**Ref.** : PT-06426

**Subject** : FIRST/Planck - FIRST Optical Bench Sharing

FIRST/Planck Project	<b>MINUTES OF MEETING</b>	Date : 16/02/1999
		Ref : PT-MM-06407
		Page : 1 of 4

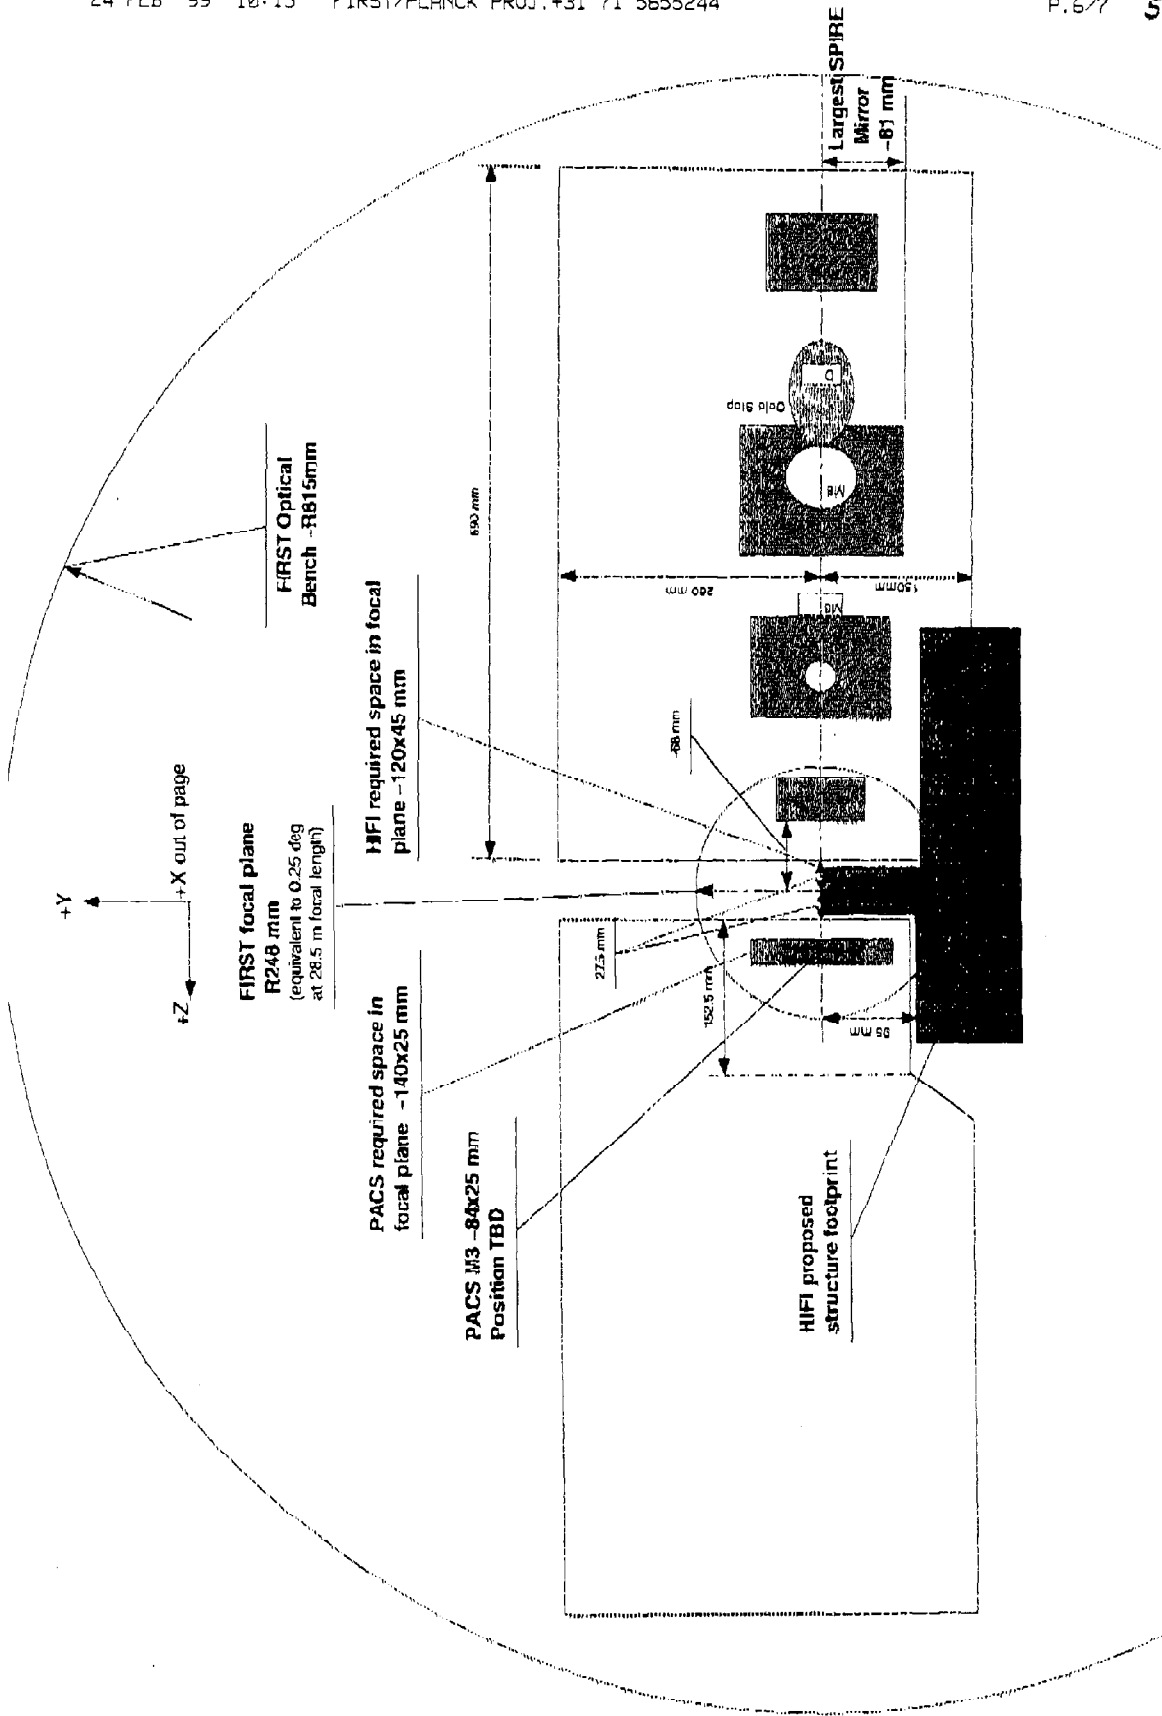
The main action on you, to confirm the feasibility to find a design that avoids need of the SPIRE corner is not answered and further, I understand from your update that the interference is increased from potentially up to 50 mm to now 60 mm.

At the interface to the PACS the length of the HIFI FPU is increased from 150 mm now to 211 mm what means another compromise with PACS.

Figure 5.3-1: The FIRST Focal Plane, side view towards -X  
 Unit dimensions and nr of LO beams out of date

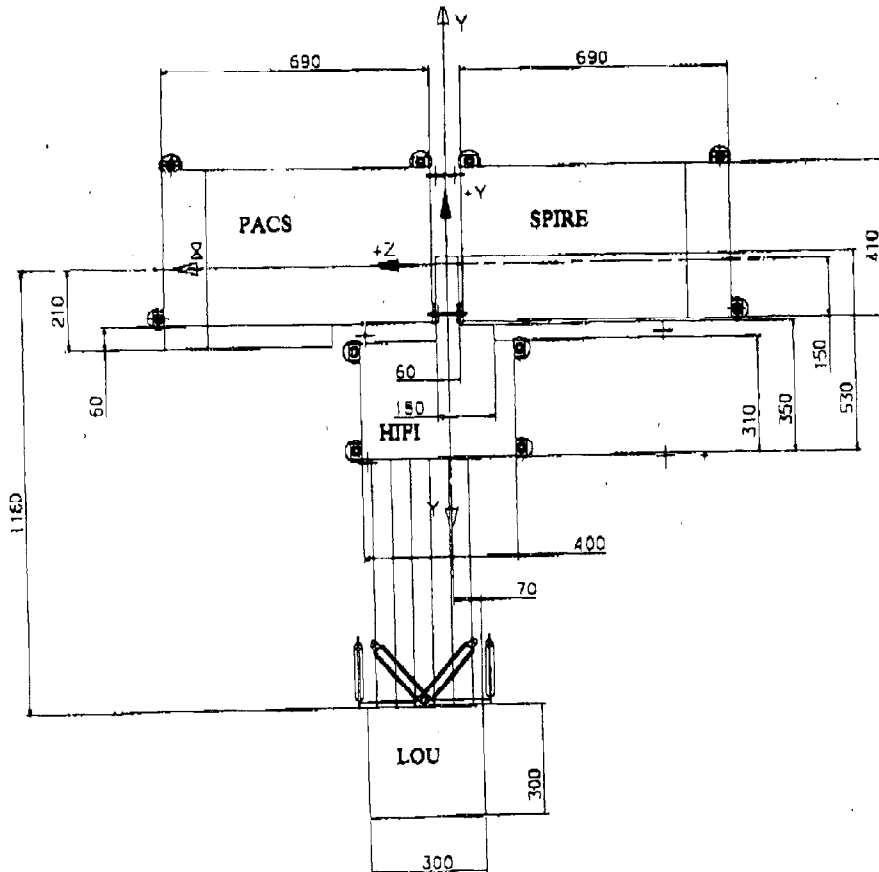
I feel forced to propose to go back to the original configuration for SPIRE and PACS and to ask you to provide a HIFI design consistent with the original HIFI envelope dimensions (attached as annex 2 to avoid any misunderstandings).
